CHANGE ORDER NO.

PROJECT: Flamson MStemporary Campus
Paso Unified School District

RE: Flamson Temp Campus
CCD 03 Grading and Utility Revisions (CPR's 02, 07R1)
Change Order Request: COR 03

Project Name: Flamson MS - Temp Campus/Interim Housing
Construction Change Document No. 03

PROJECT ARCHITECT	PROJECT NUMBER	SHEET NUMBER
DAVID IWANAGA	17-58	DET 1.0
RF	DRAWN BY	SCALE
RAFAEL FERREIRA	06/04/2019	DATE

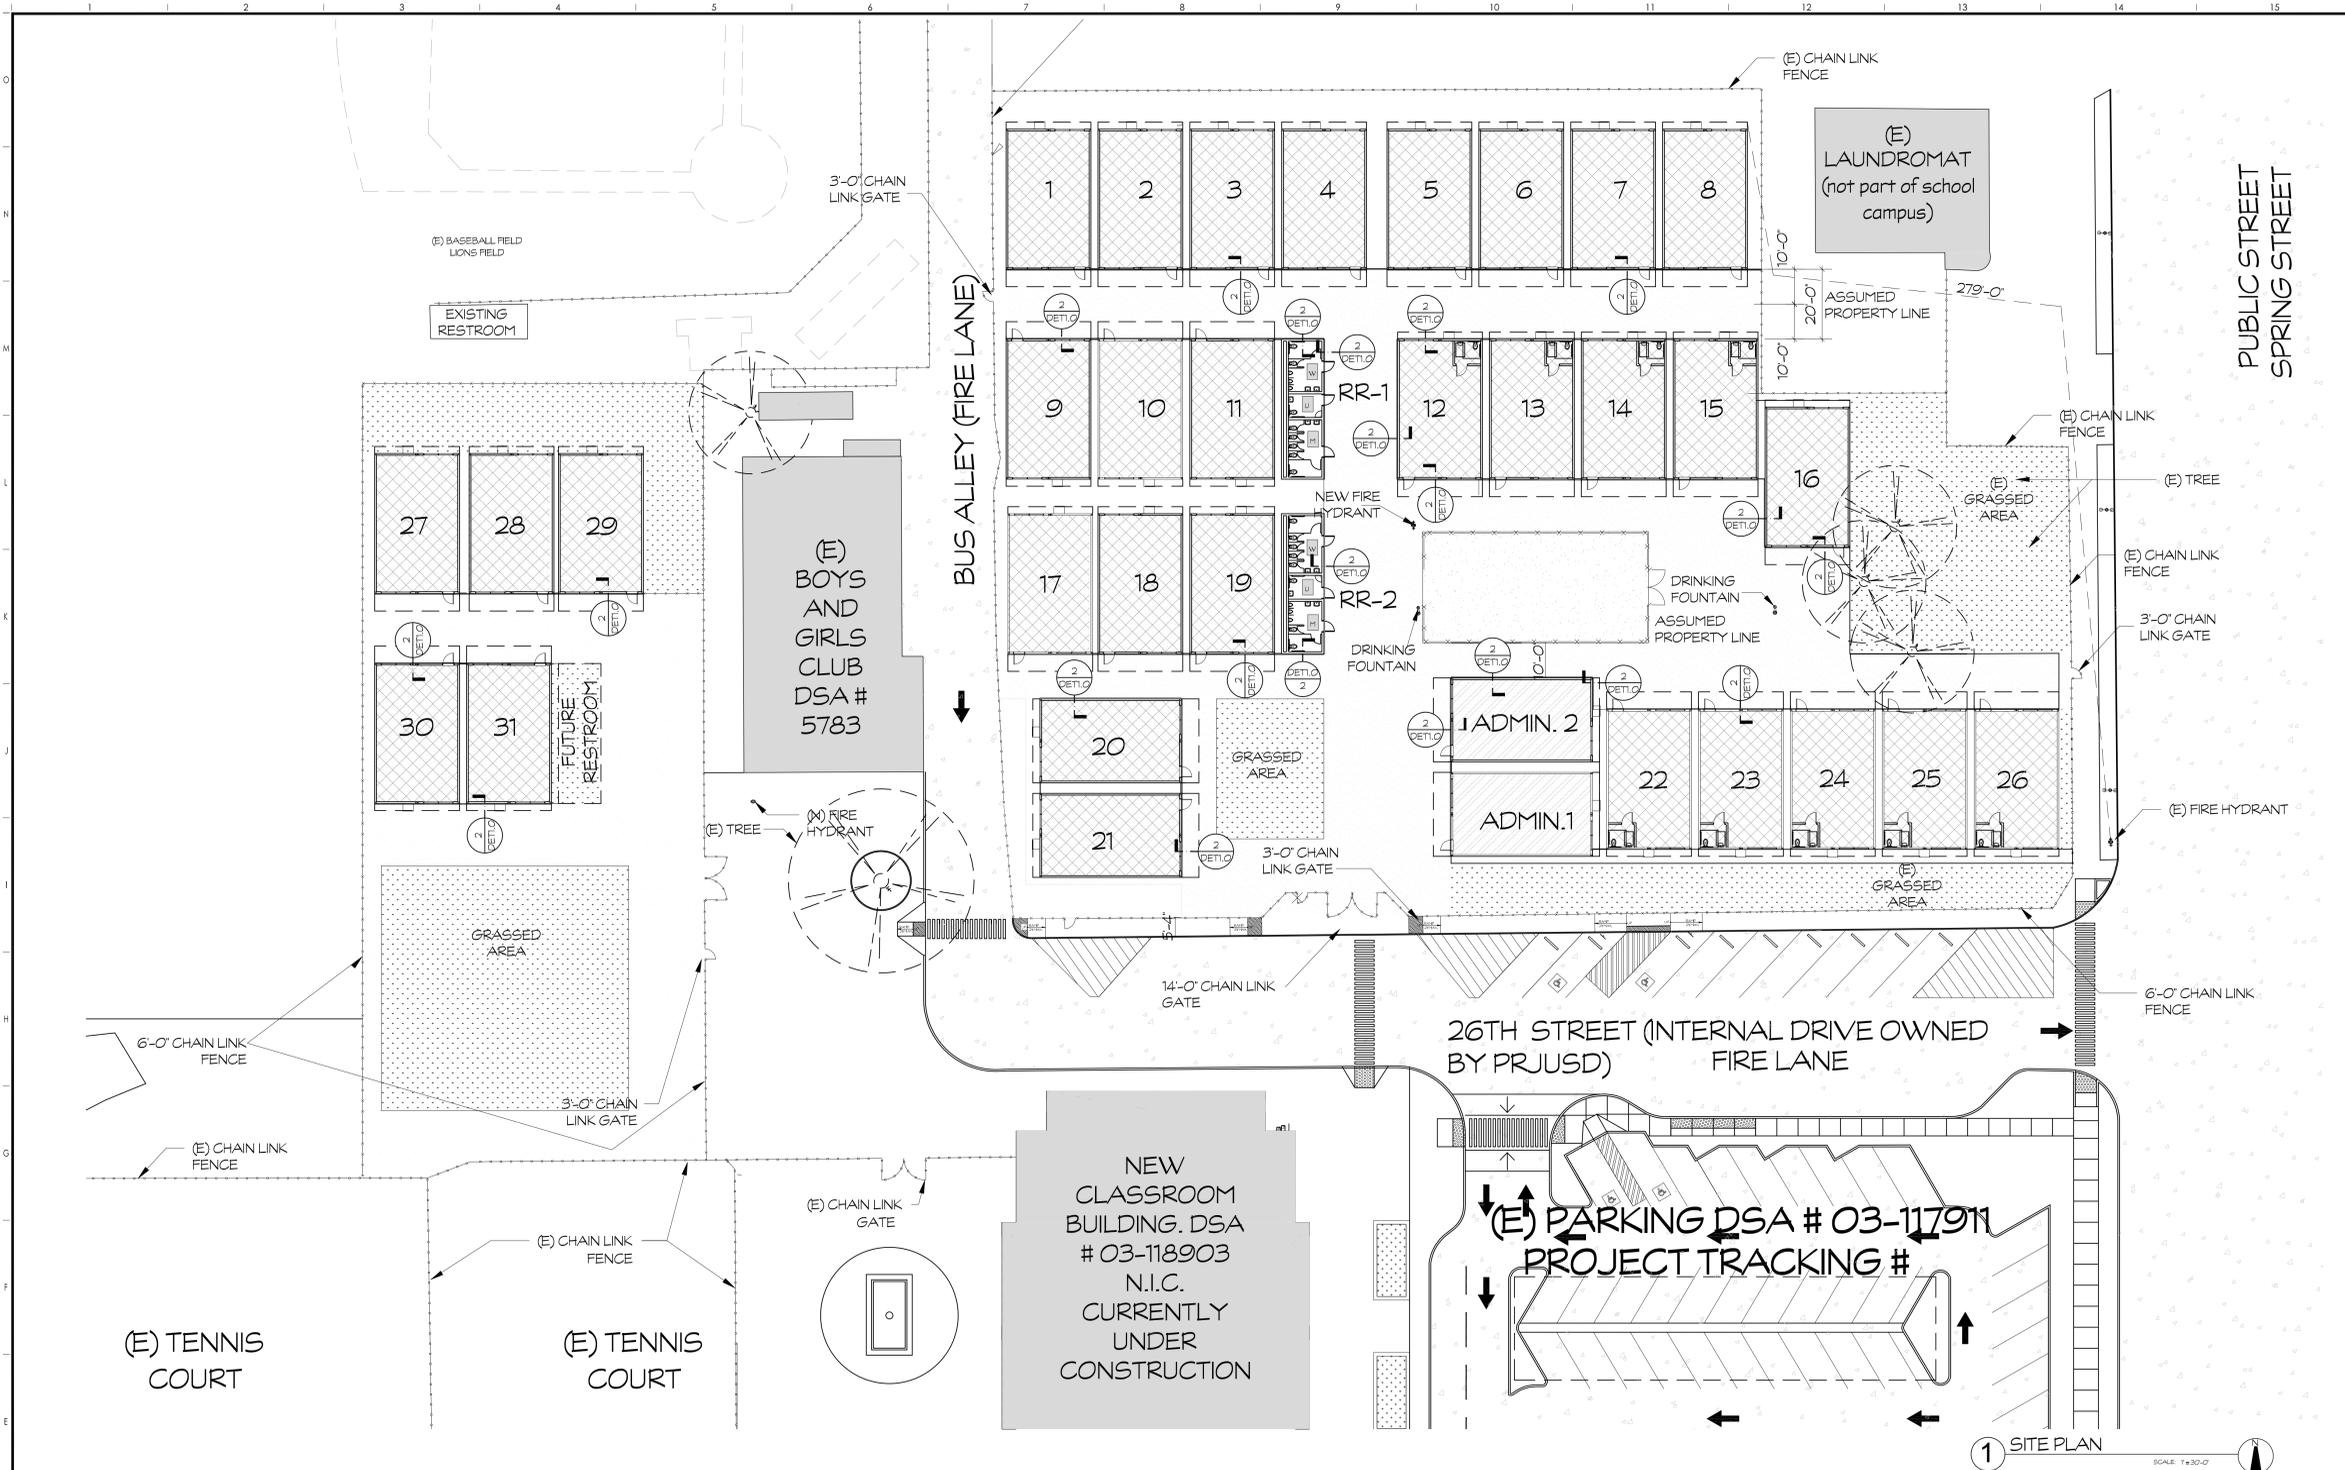
1. Provide pricing for modified Detail A/C4 with added vent detail for concrete sidewalk adjacent to portable buildings to comply with DSA Requirements. See attached Drawing DET1.0 as part of CCD 05A.

Description of Work: Contractor to provide pricing for modified detail A/C4 with added vent detail for concrete sidewalk adjacent to portable buildings to comply with DSA requirements.

ENLARGED SITE PLAN
SHEET NUMBER: DET 1.0

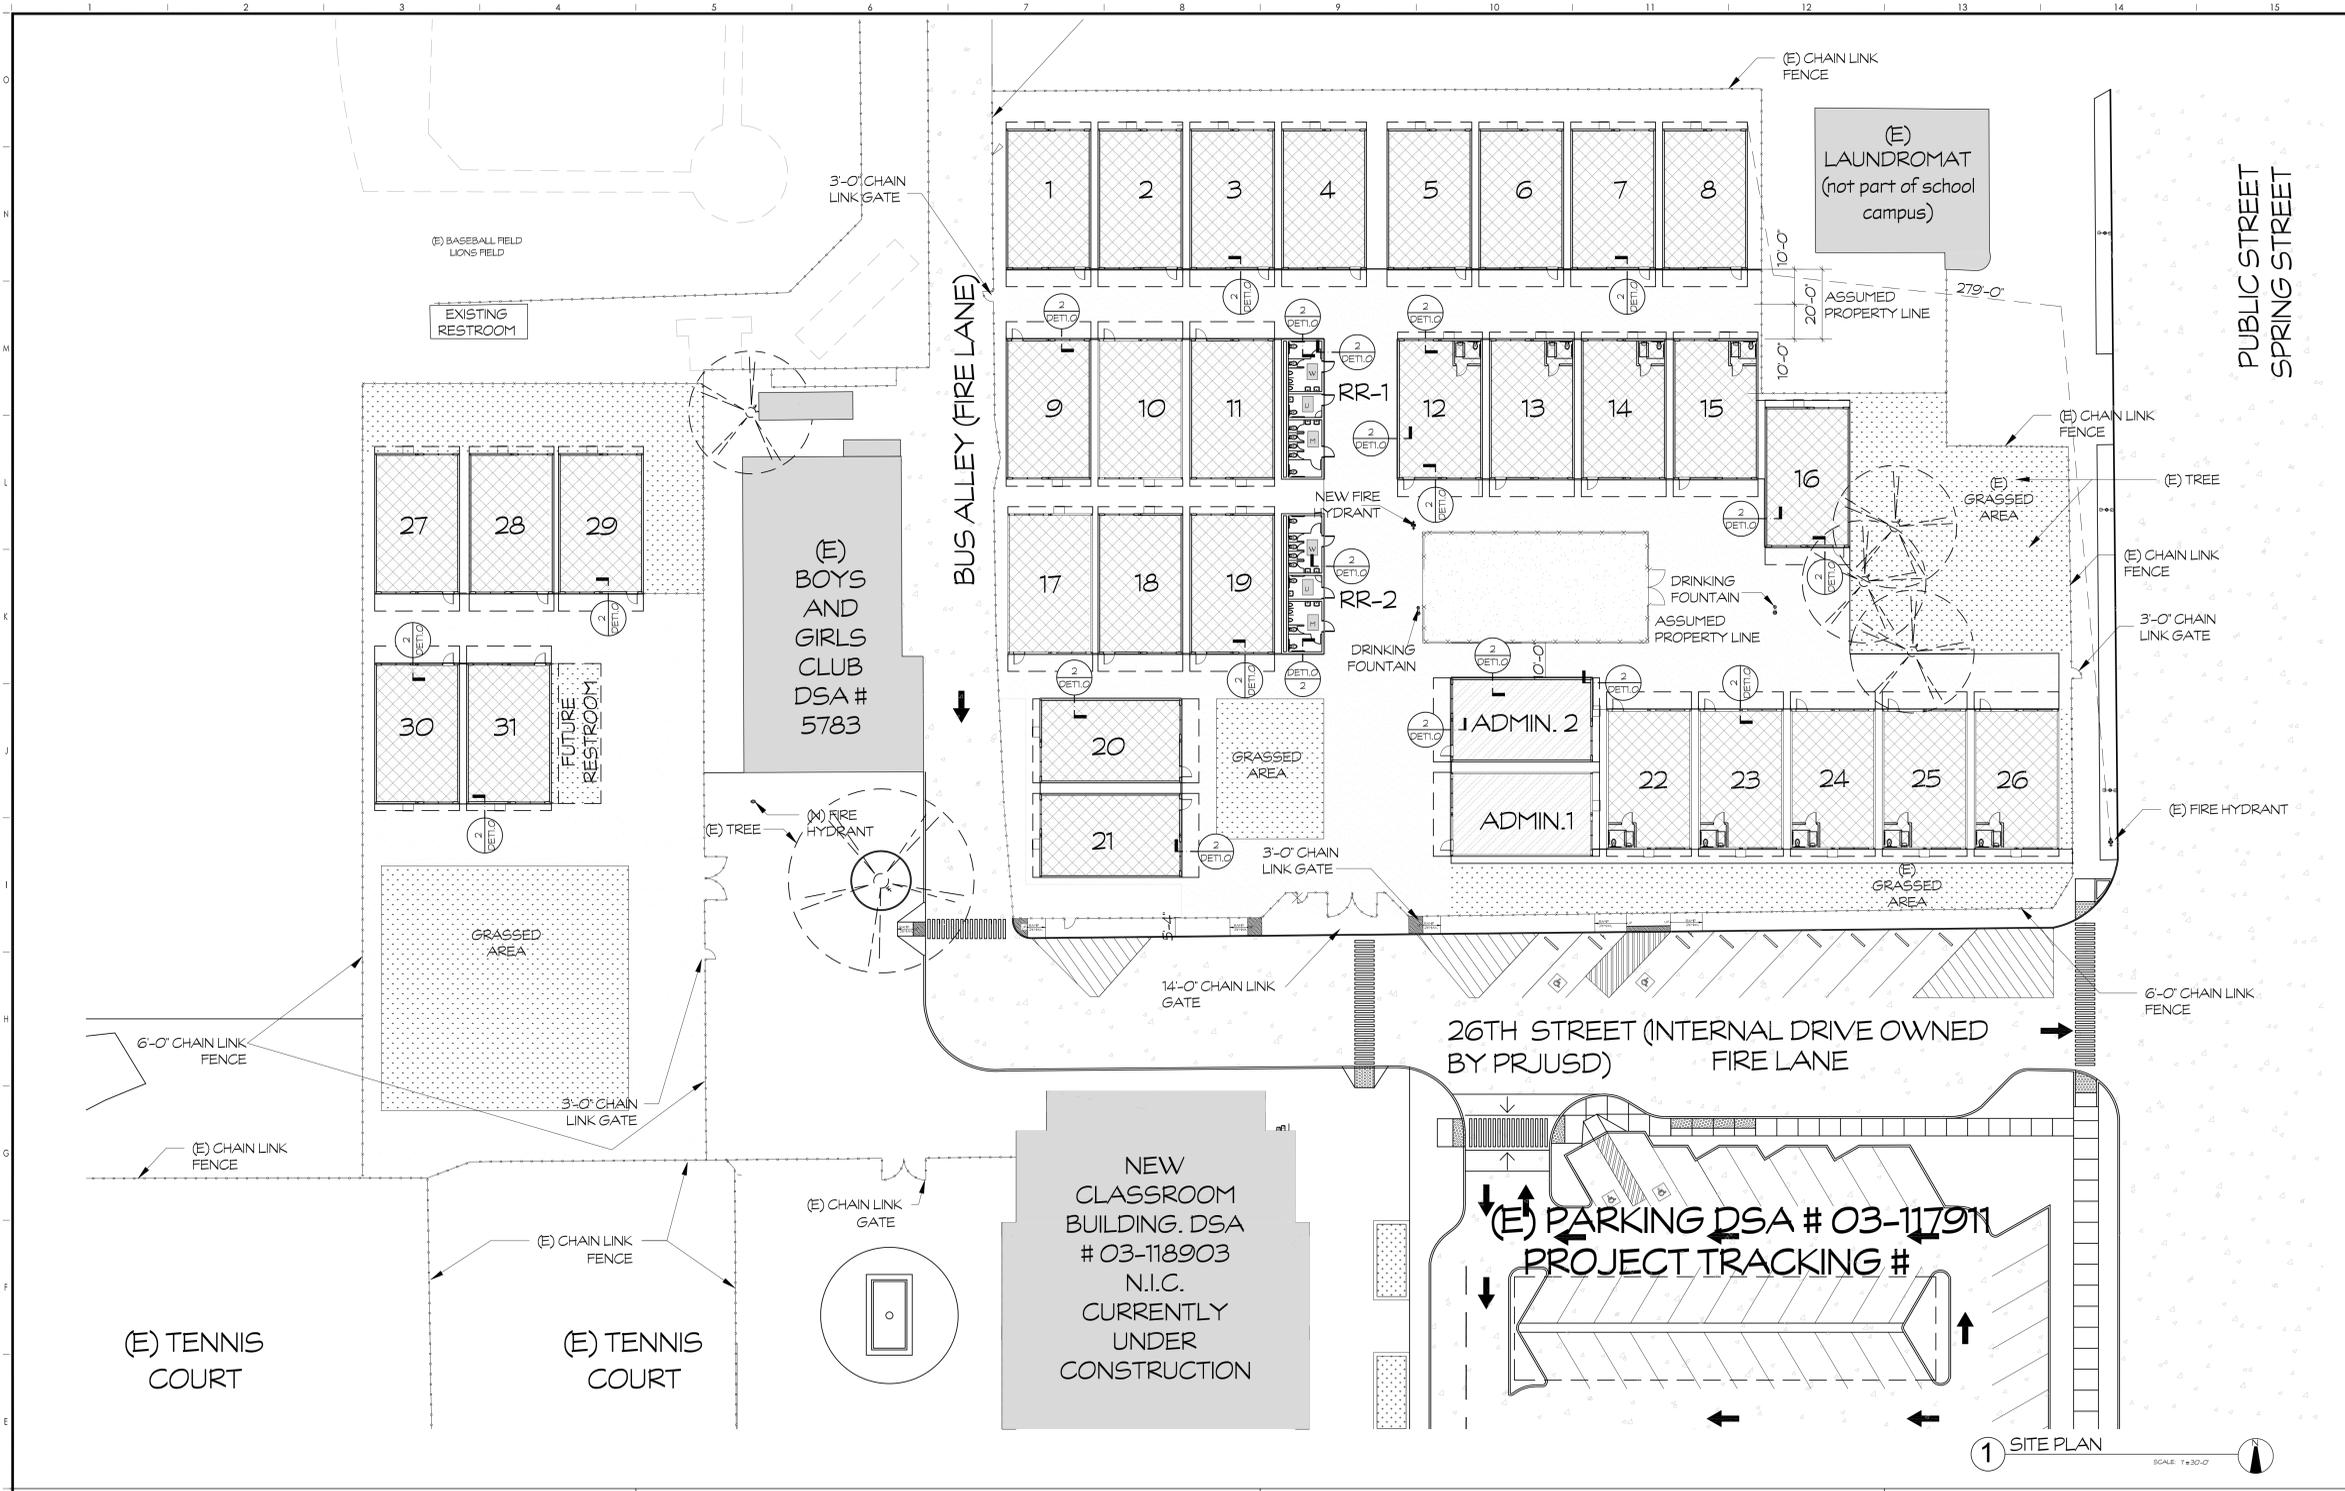
NOTE: PROVIDE SOLID TRENCH COVER AT DOOR ENTRANCES
